Arlington High School Building Committee

Meeting Date: **Tuesday, March 2, 2021 - 6:00 pm**
Location: **Conducted via Remote Participation**

AHSBC 3/2/21 MEETING MATERIALS TABLE OF CONTENTS

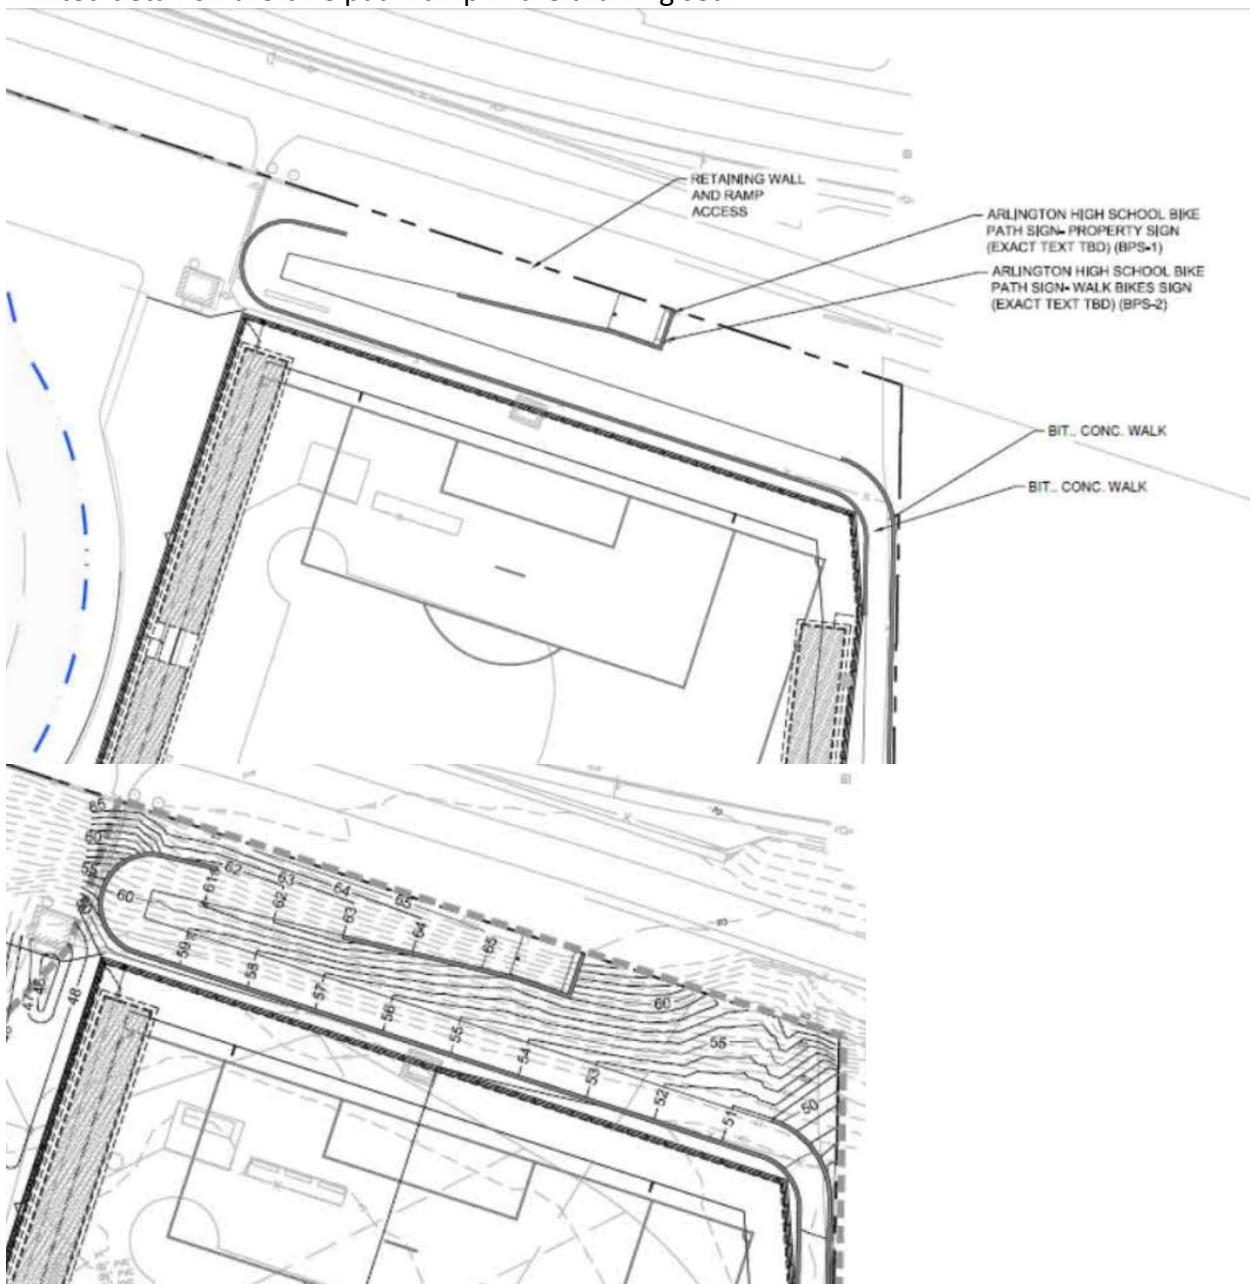
Limited detail on the bike path ramp in the drawing set.

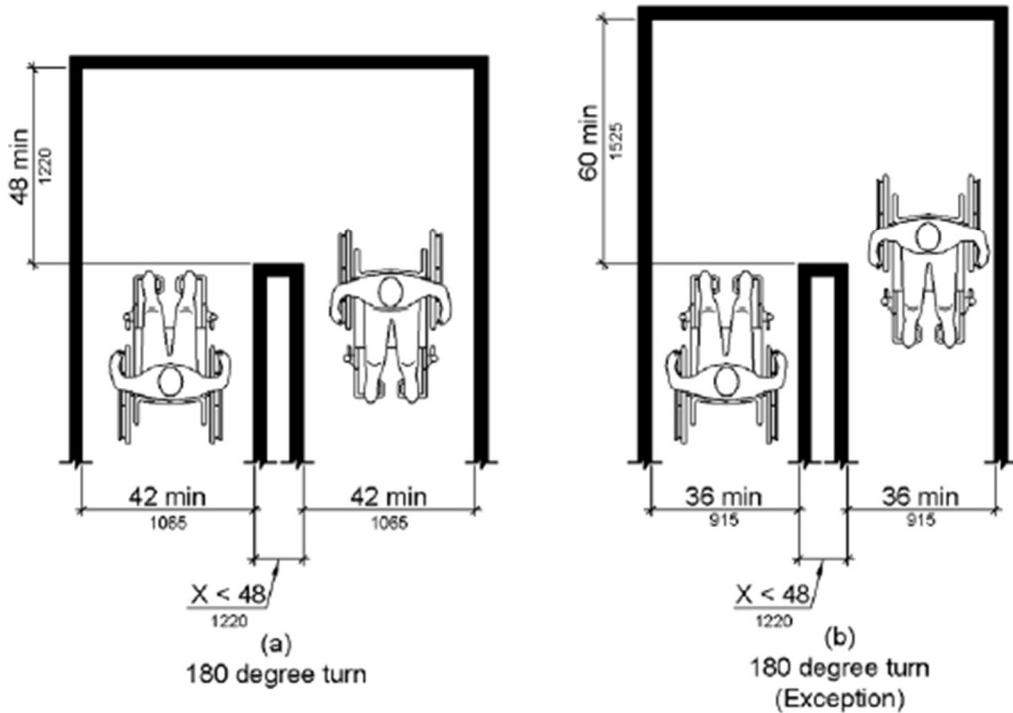
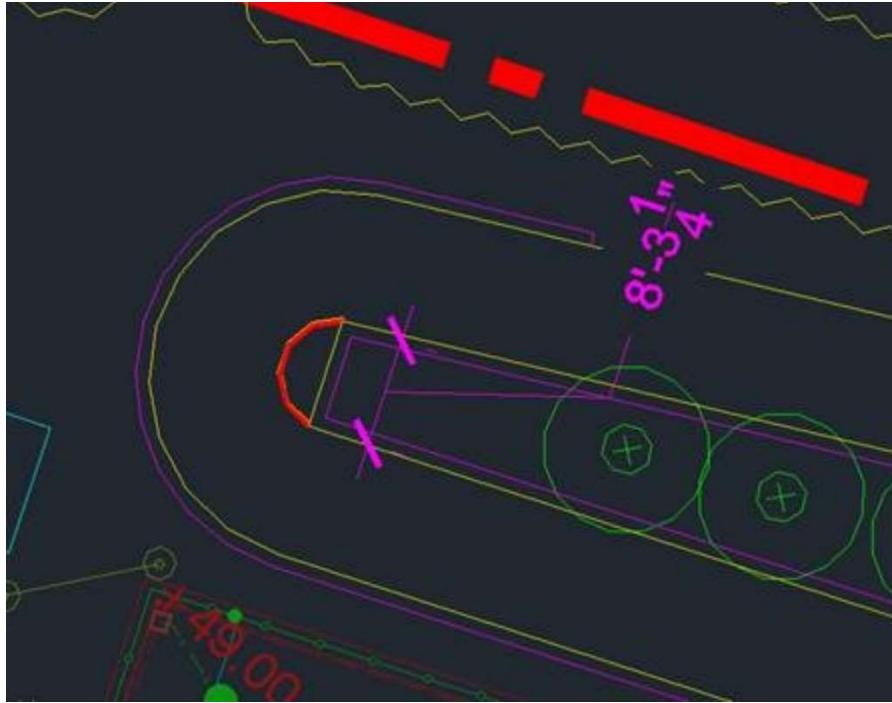
2010 ADA Standards: 403.5.2 Clear Width at Turn. Where the accessible route makes a 180 degree turn around an element which is less than 48 inches (1220 mm) wide, clear width shall be 42 inches (1065 mm) minimum approaching the turn, 48 inches (1220 mm) minimum at the

See diagram below, the clear width at the turn is greater than 60".

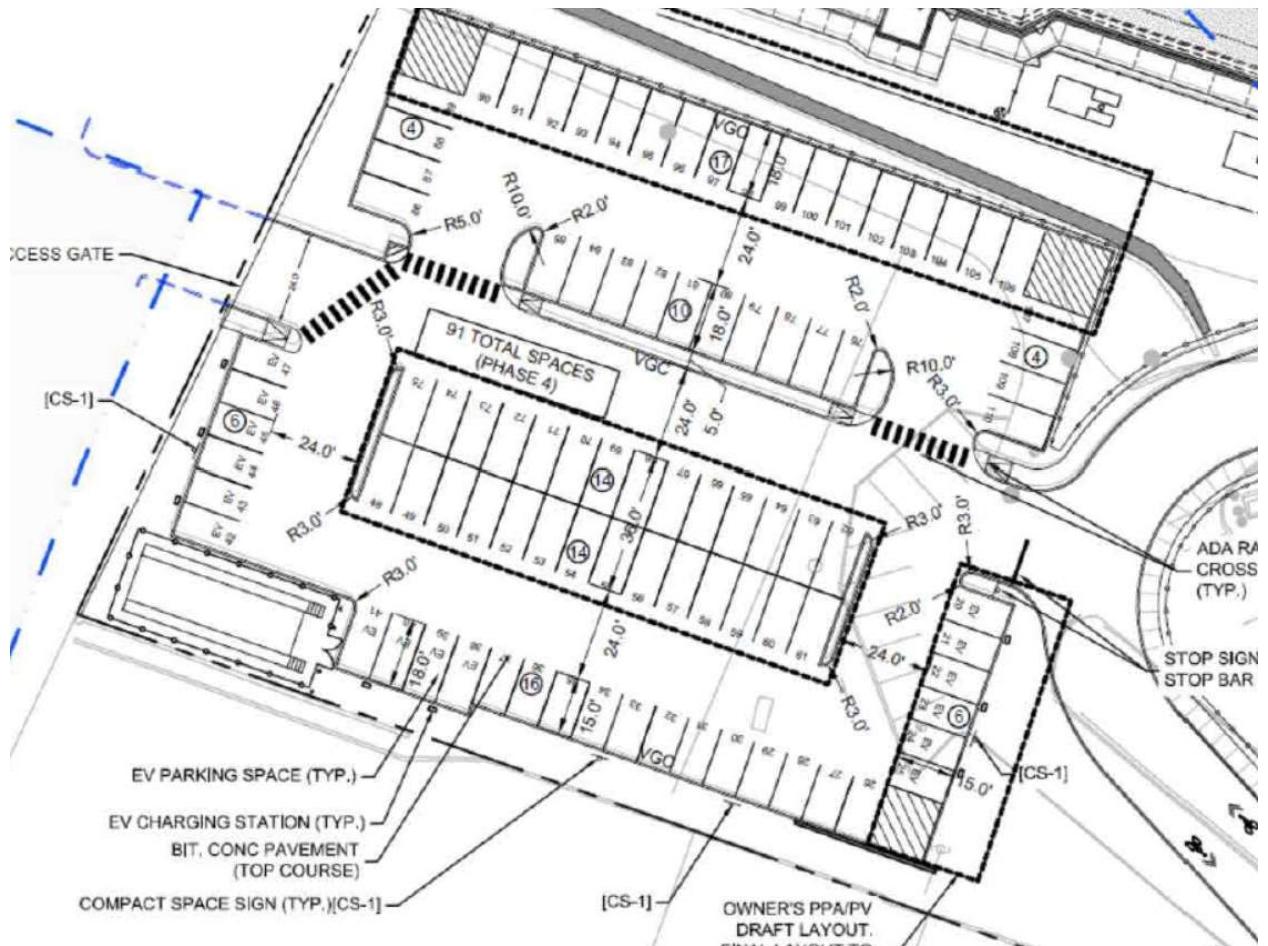
No accessible parking spaces are located in this lot. This may only be a parking lot for staff but the public may use this lot some times. The US Access Board requires that accessible parking spaces for each parking facility on a site, such as lots and garages: <https://www.access-board.gov/ada/guides/chapter-5-parking/#accessible-parking-on-a-site>

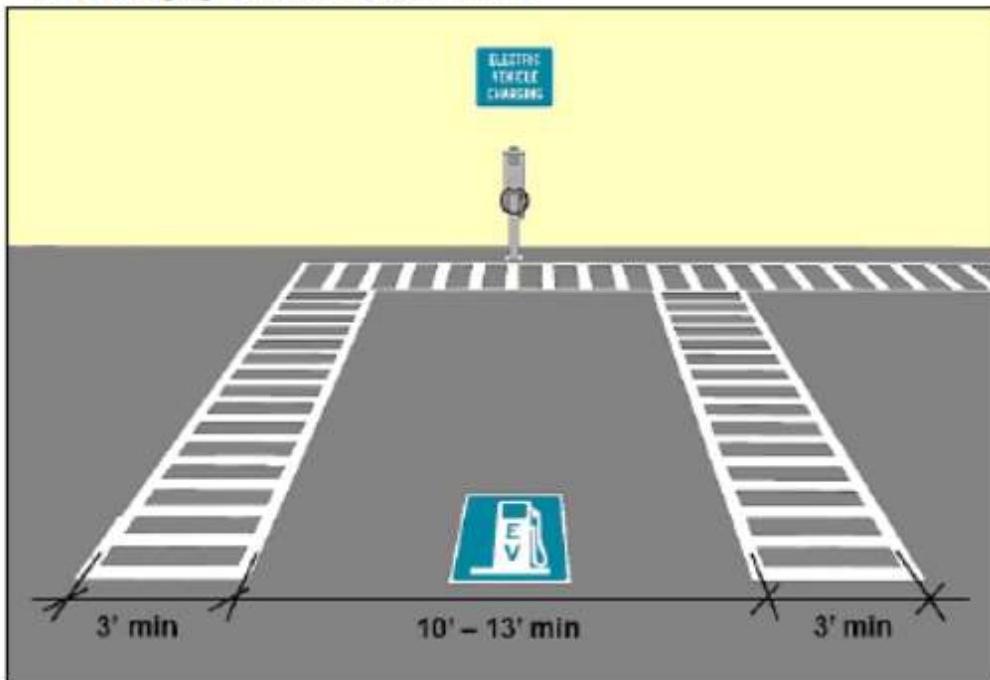
Recommendations: Provide access to a reasonable number of spaces serving EV charging stations or use the scoping table in §208.2 to determine an appropriate number. (The number of accessible spaces serving EV charging stations must be determined separately from the required number of car and van parking spaces.)

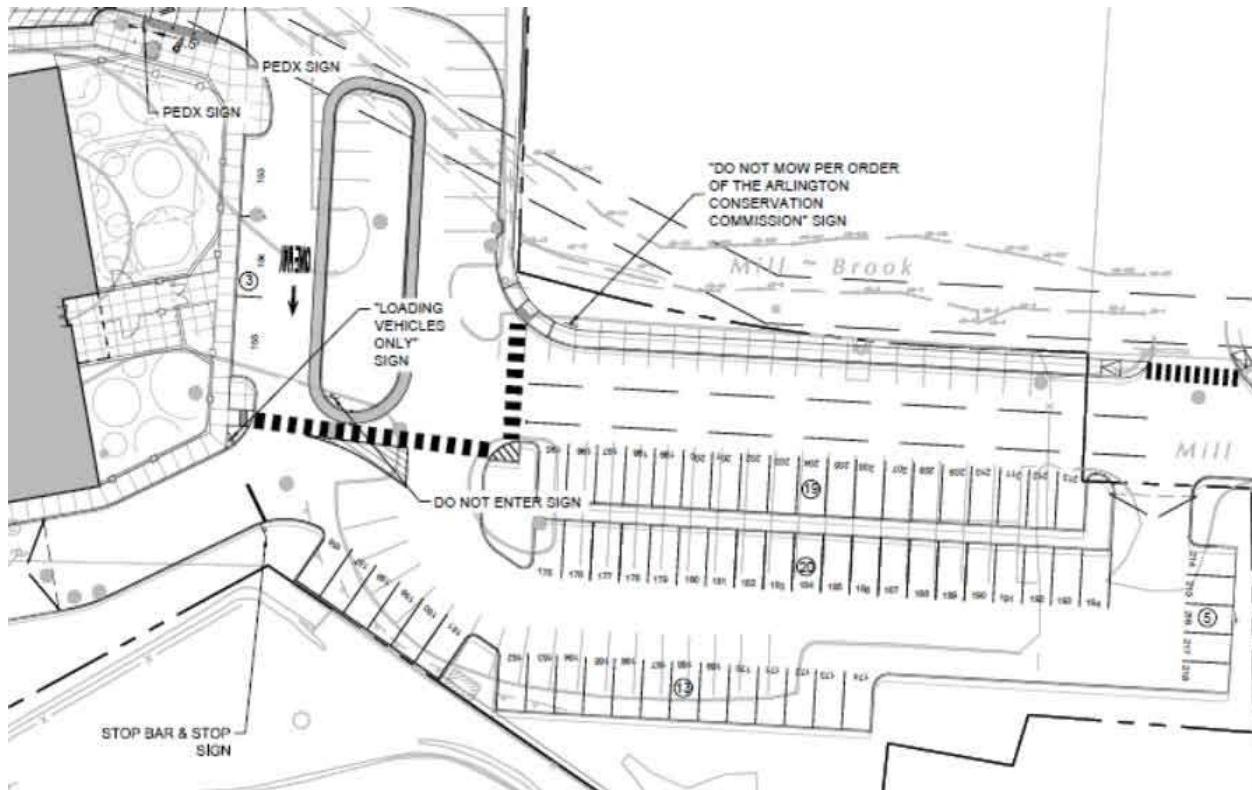
A vehicle space at least 10' – 13' wide is advisable. A 10' width offers an extra 2' that effectively provides a 5' aisle on one side when paired with the accessible route; a 13' wide space will allow an 8' aisle. This flexibility is helpful since the parking direction is determined by the location of the charging station and the vehicle connection. Use the International Symbol of Accessibility only where spaces are reserved exclusively for people with disabilities.
